SUBJECT: O'FALLON COMMUNITY PARK ENHANCEMENTS
NEW POOL AND AMPHITHEATER (PHASE 1)
411 EAST 5TH STREET
O'FALLON, IL 62269

FGM Project No.: 23-3773.01

This Addendum forms a part of the Bidding and Contract Documents and modifies the original bidding documents dated February 14, 2024, and project Addendum #1 documents dated February 26, 2024. Acknowledge receipt of this Addendum in space provided on Bid Form. **Failure to acknowledge addenda may subject bidders to disqualification.**

**FOUNDATION PLAN AREA
A-D**
SHEET NO.
S1.0
JOB NO. 23-3773.01
© 2023 FGM Architects Inc.

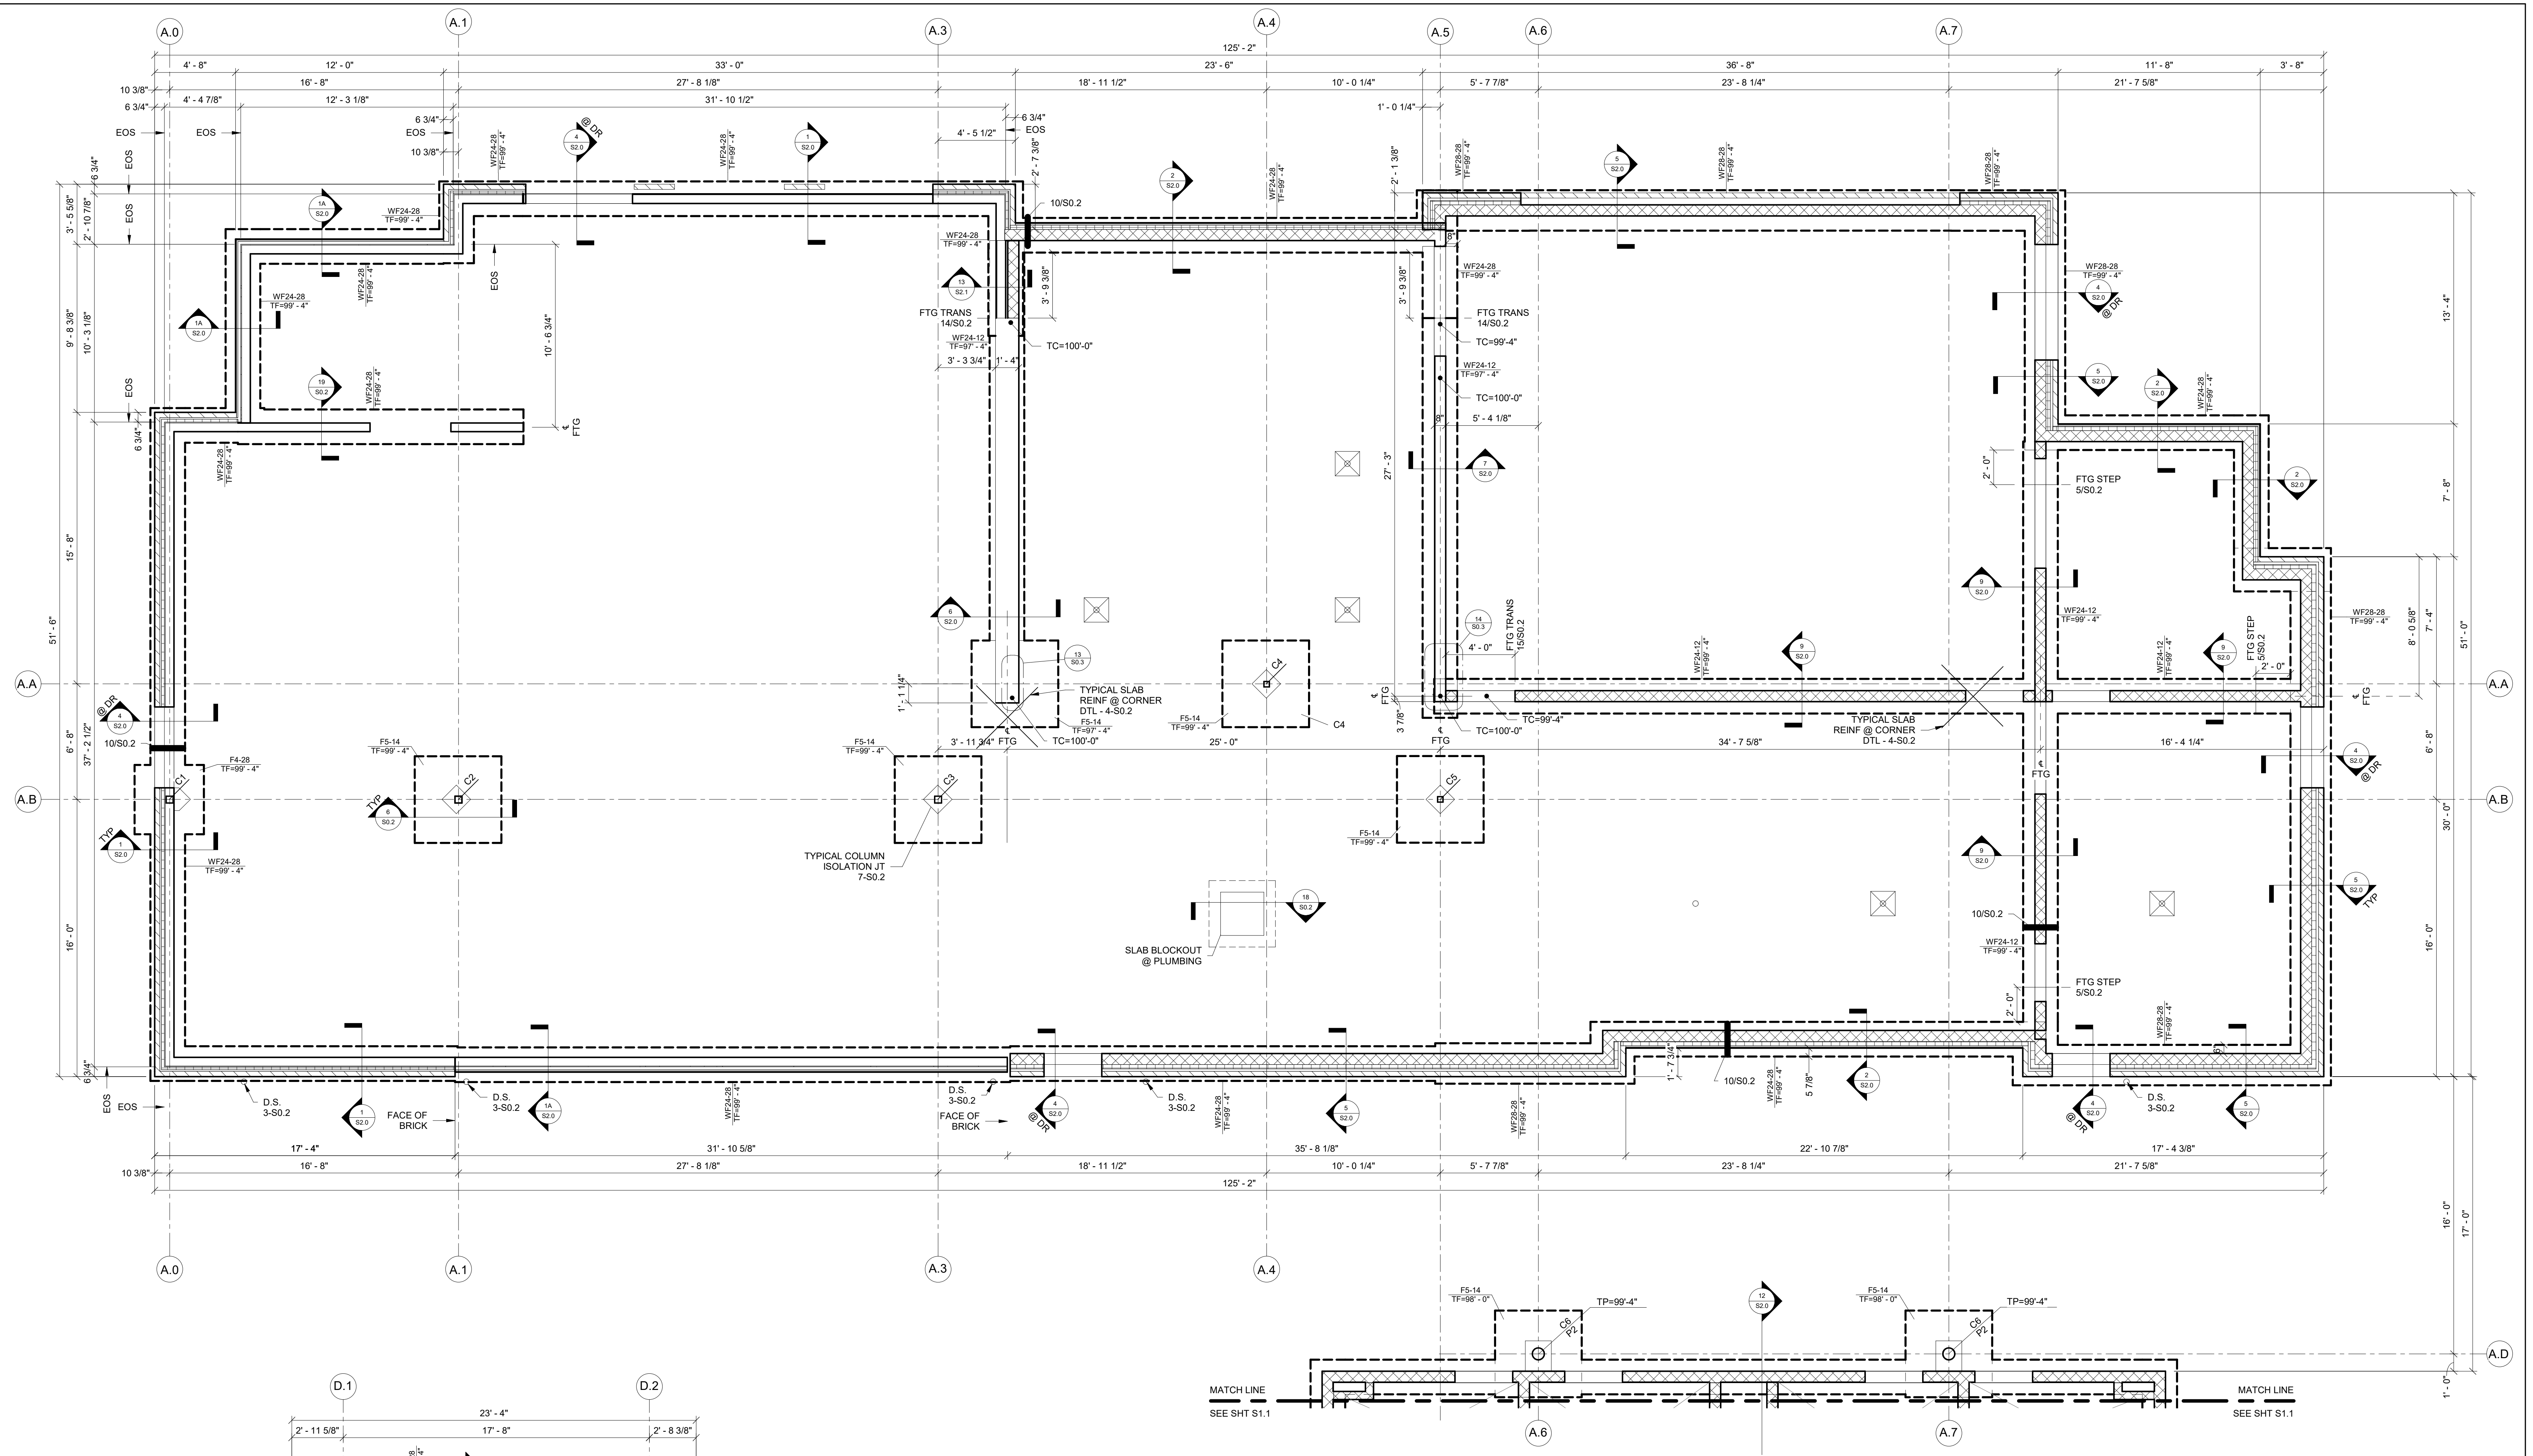
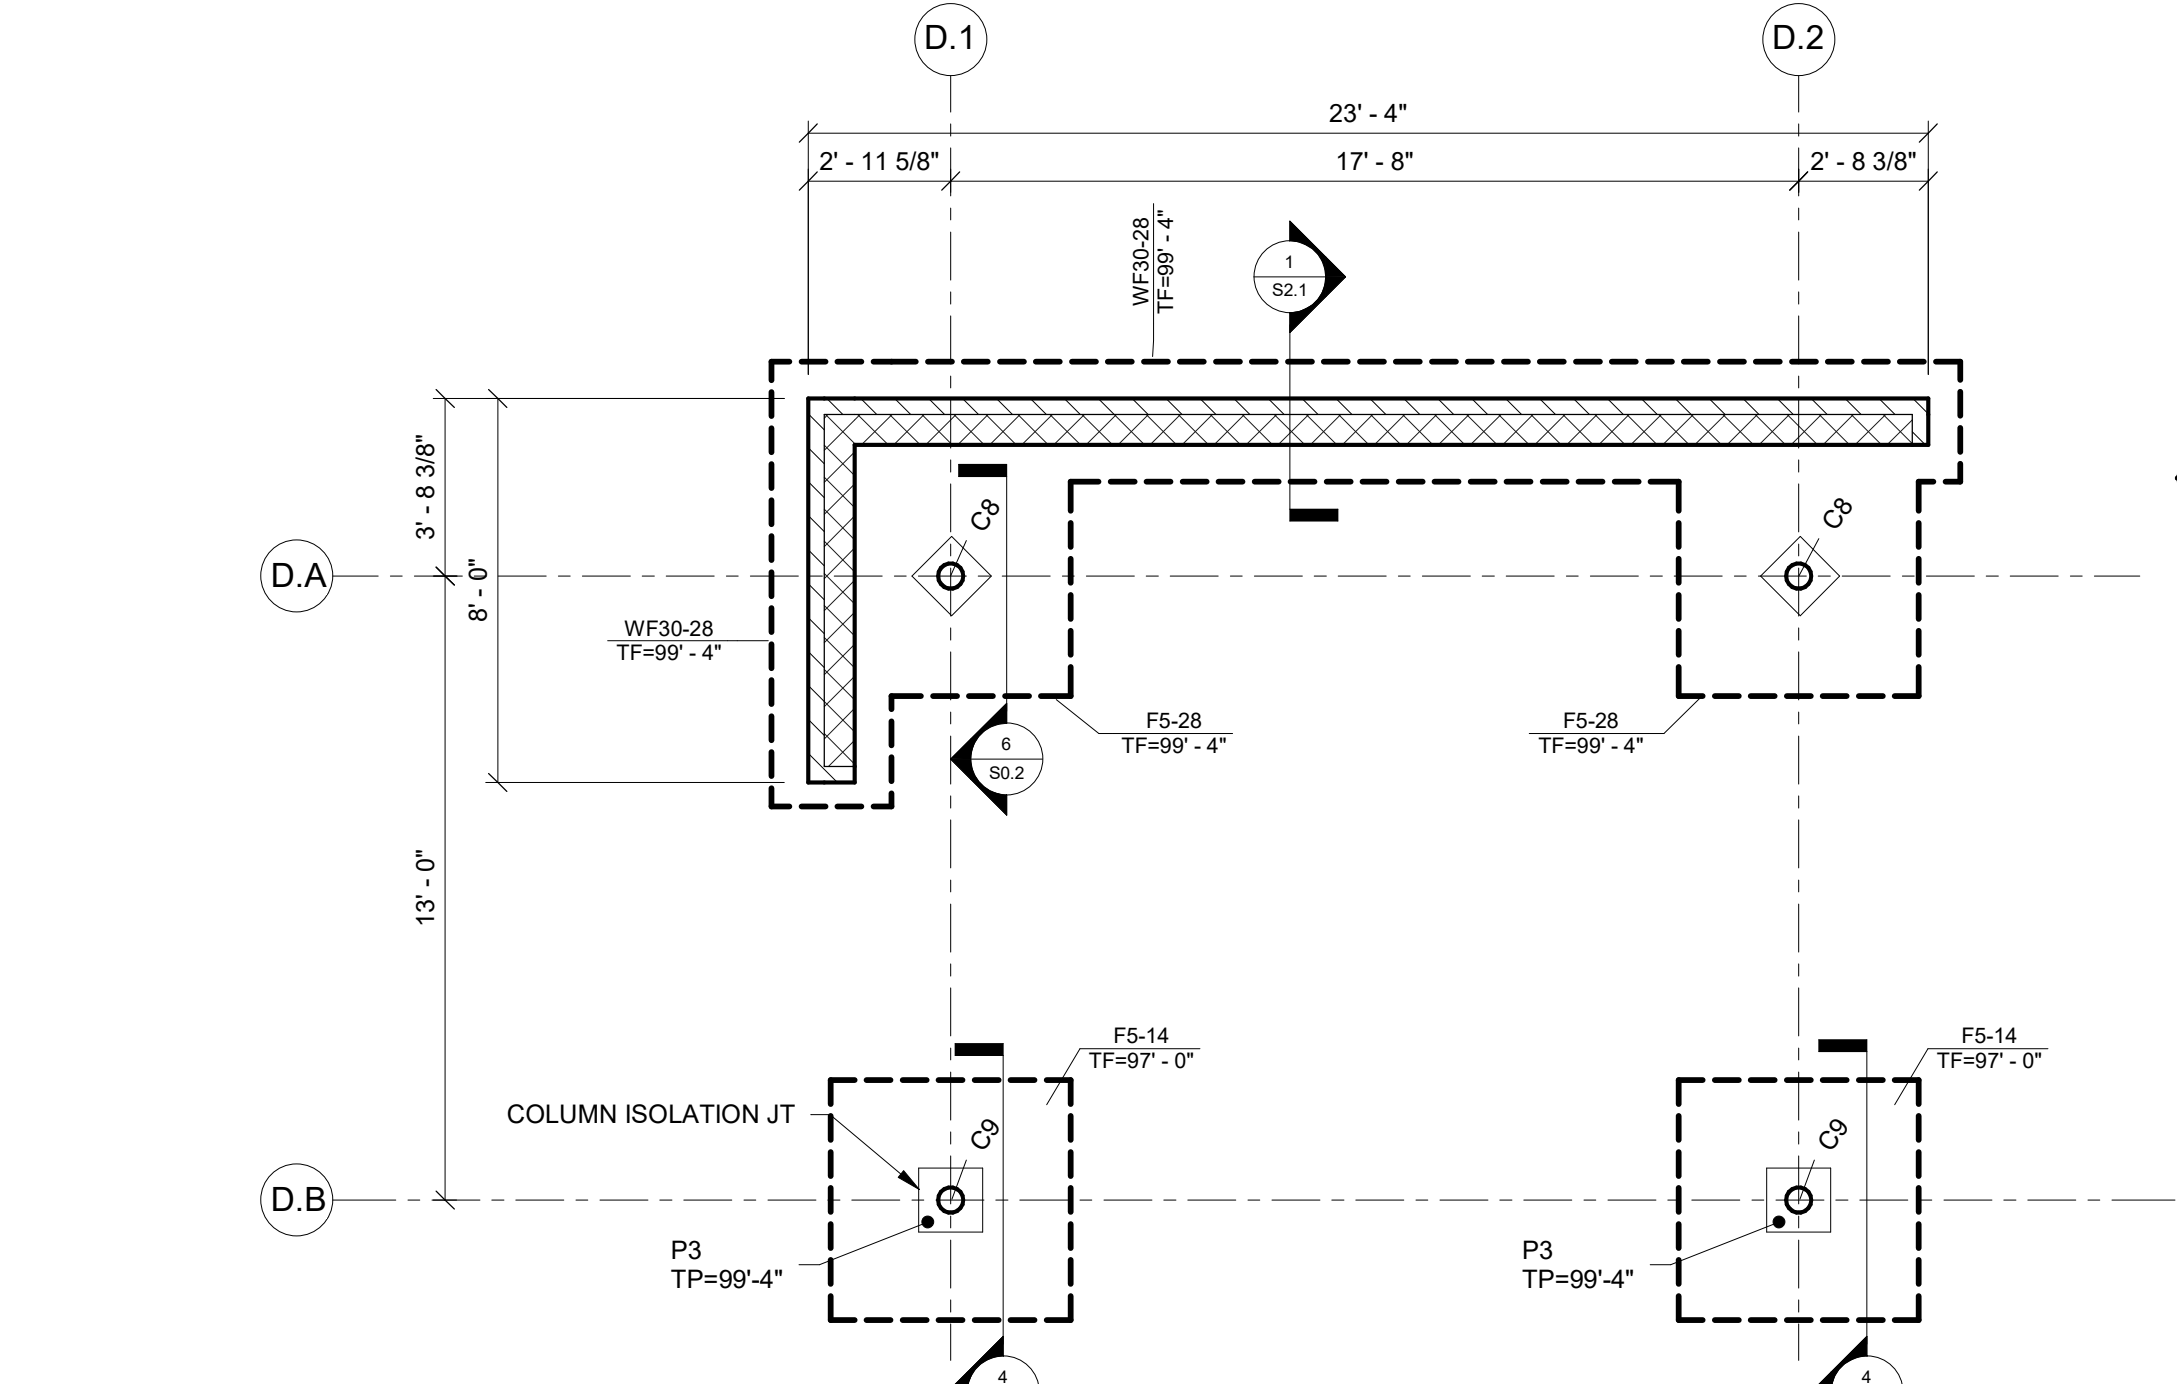
- A. **REVISE** plan note 5 of **FOUNDATION PLAN AREA A**: - Change allowable soil bearing pressure from 1500 psf to "**2250 psf**".

SHEET NO.
S1.1

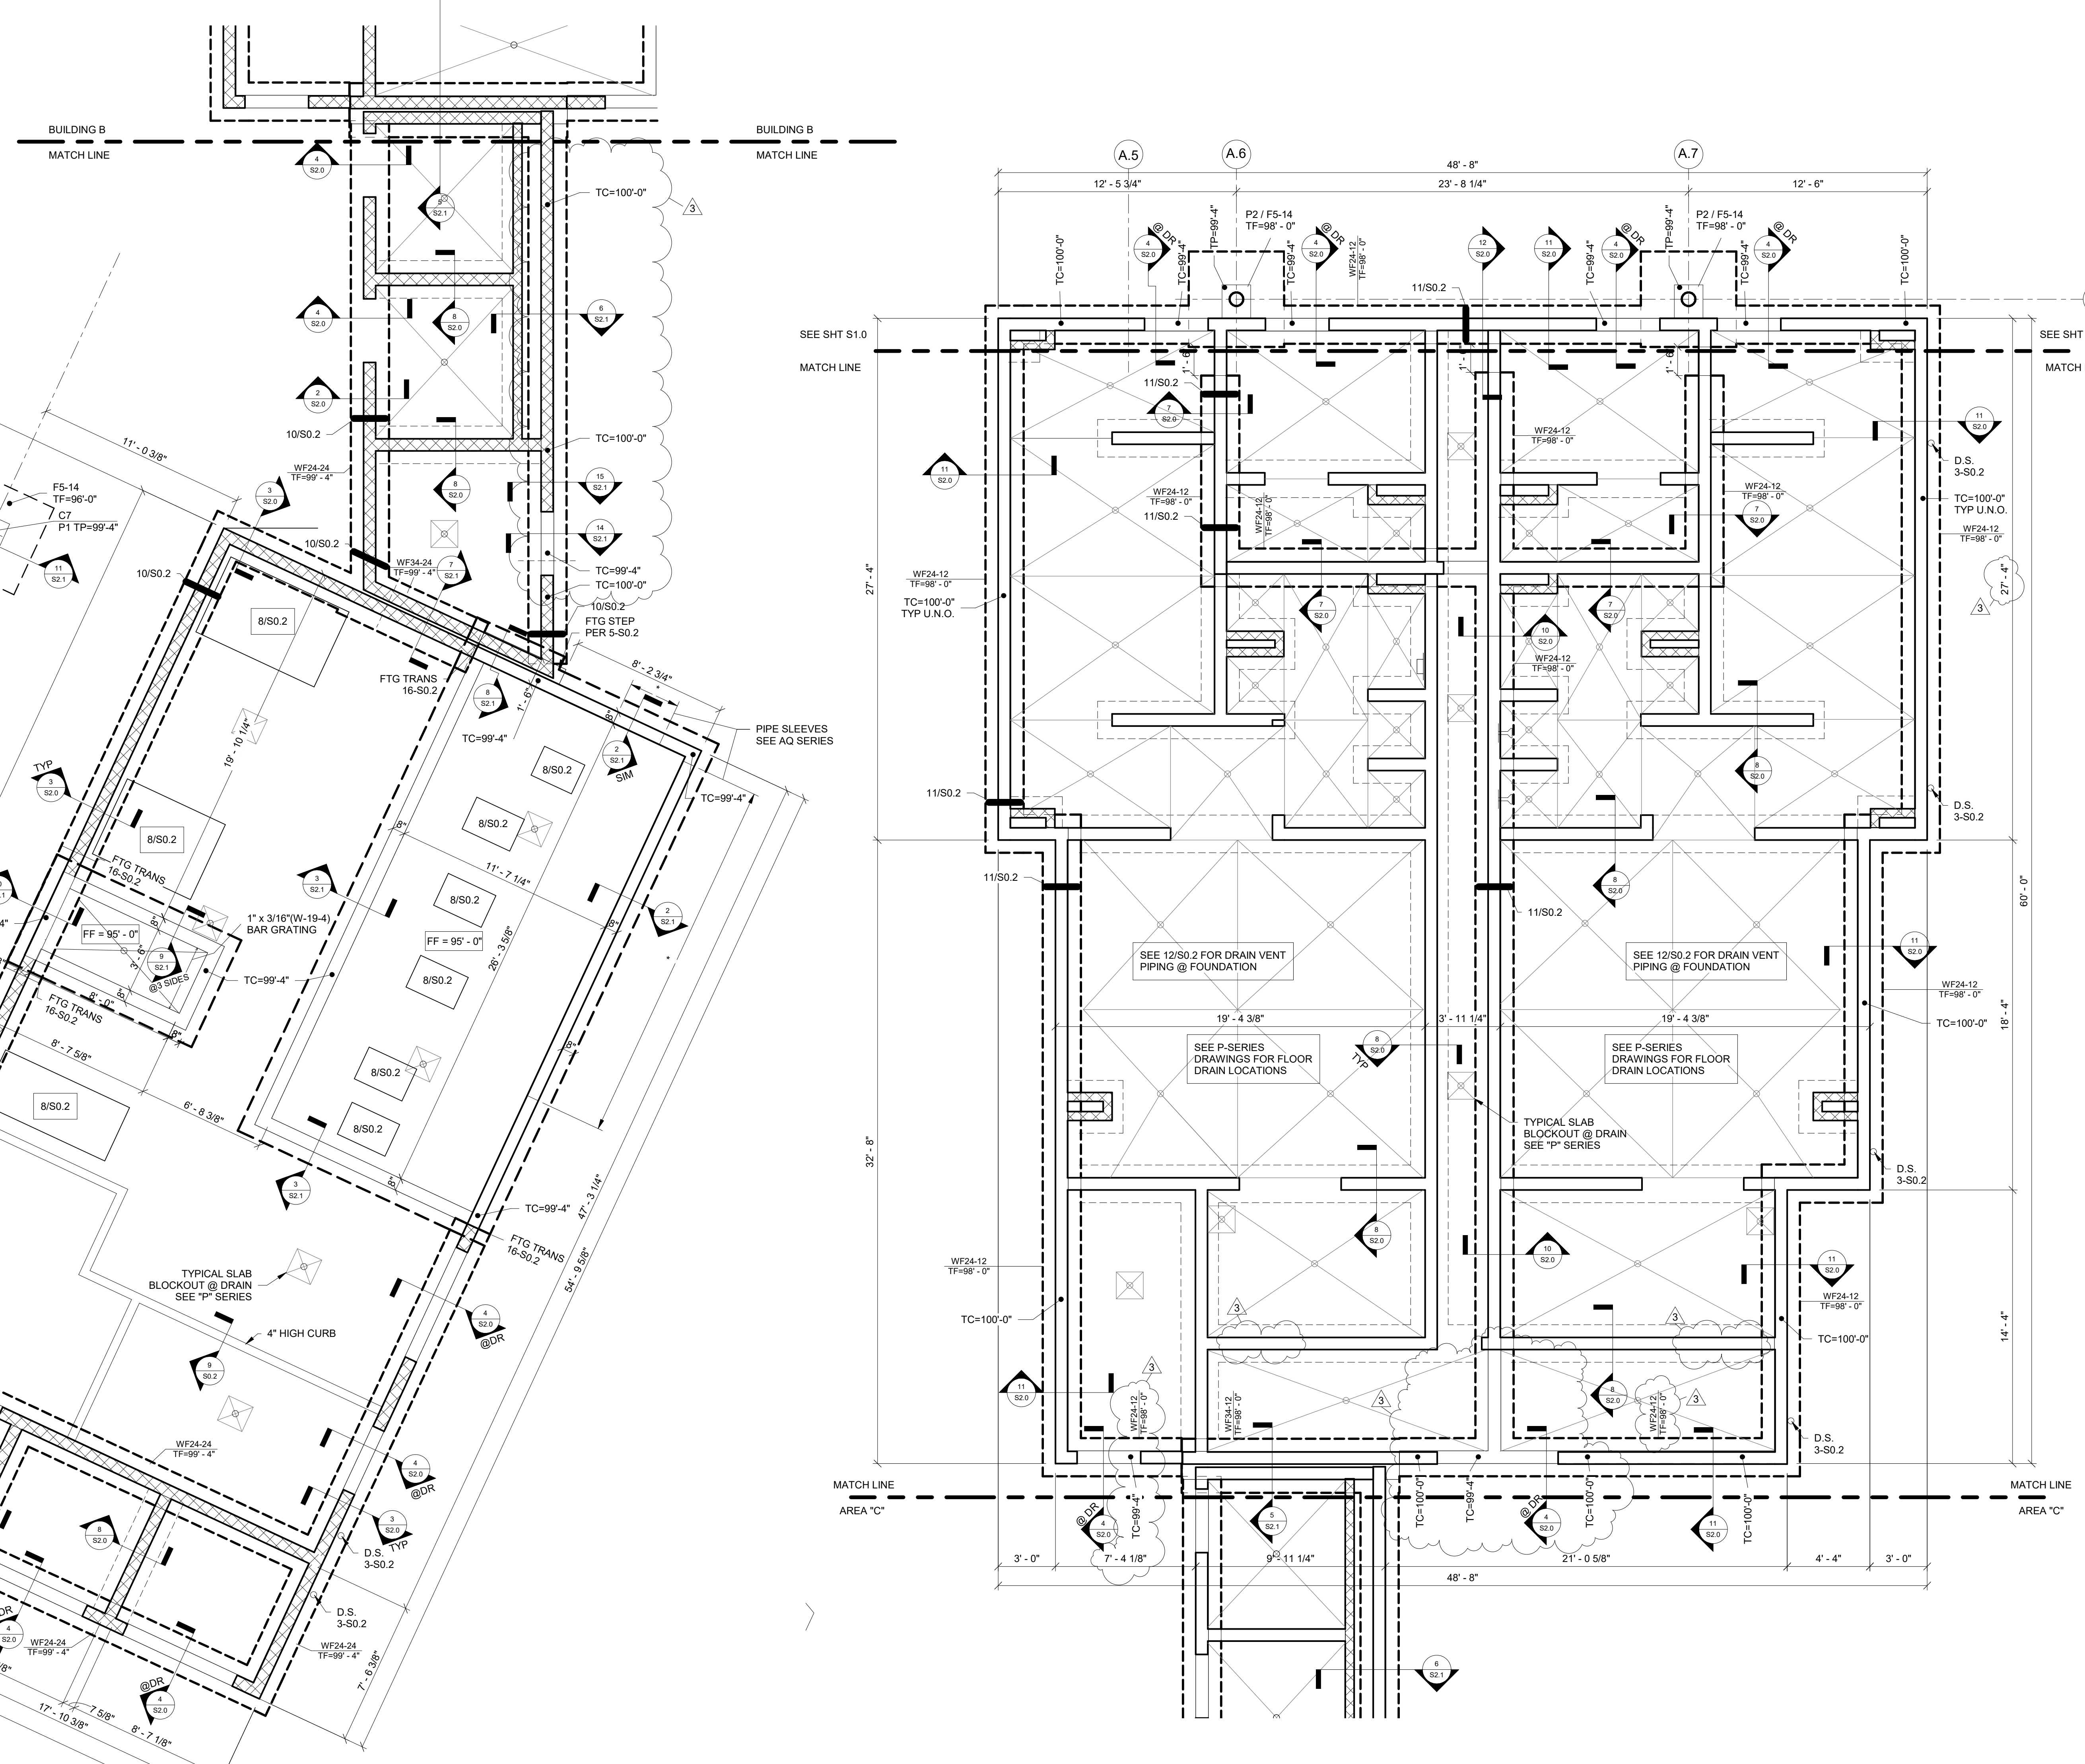
- A. **REVISE** plan Note 5 of **FOUNDATION PLAN AREA B**: - Change allowable soil bearing pressure from 1500 psf to "**2250 psf**".
- B. **REVISE** plan Note 5 of **FOUNDATION PLAN AREA C**: - Change allowable soil bearing pressure from 1500 psf to "**2250 psf**".

- C. **ADD** dimension string **27'-4"** on East side of building.
- D. **ADD** dimension string **7'-4¼"** on South side of building.
- E. **ADD** wall footing dimension callout along South wall to **WF24-12/TF-98'-0"**.

- I. **REMOVE** Door opening @ Door B135.1 and Door B105.1.
- J. **REMOVE** Masonry wall and Footing between Rm. B135 and Rm. B105.
- K. **ADD** Door opening for new 6'-0" door in South wall of Bldg. B.
